[Docket No. FAA–2009–1088; Directorate Identifier 2008–SW–76–AD]

Airworthiness Directives; Sikorsky Aircraft Corporation Helicopters

ACTION: Supplemental notice of proposed rulemaking (NPRM); reopening of comment period.

Figure 1-2A to Paragraph (d), Maximum Gross Weight for HEC Requiring Cat 'A'

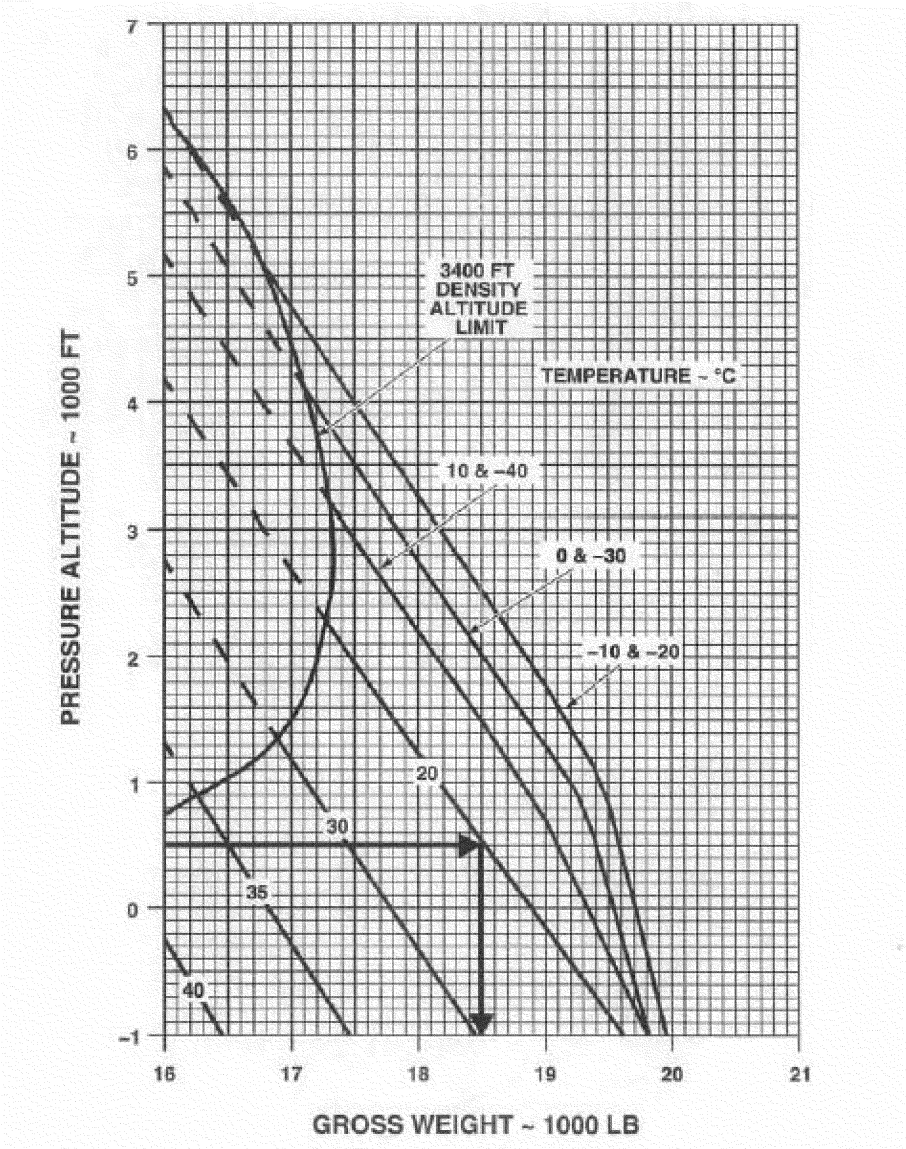
(ii) Add this paragraph and figure: ''HOIST Maximum gross weight for Human External Cargo, which requires category 'A' performance capabilities, is limited to the gross weight determined in accordance with the following Figure 1–2A to Paragraph (d) of this AD for your altitude and temperature with the air-conditioner, anti-ice, and bleed air turned off.''

NOTE 1 to Figure 1-2A to Paragraph (d) of this AD: THIS CHART DEPICTS THE GROSS WEIGHT, PRESSURE ALTITUDE, TEMPERATURE COMBINATION WHERE OEI HOGE CAPABILITY EXISTS USING 30 SECOND OEI POWER WITH A 60 SHP MARGIN.

NOTE 2 to Figure 1-2A to Paragraph (d) of this AD: 15 FT OF GROUND CLEARANCE IS ASSURED IN THE EVENT OF AN ENGINE FAILURE AT 20 TO 80 FT AGL.
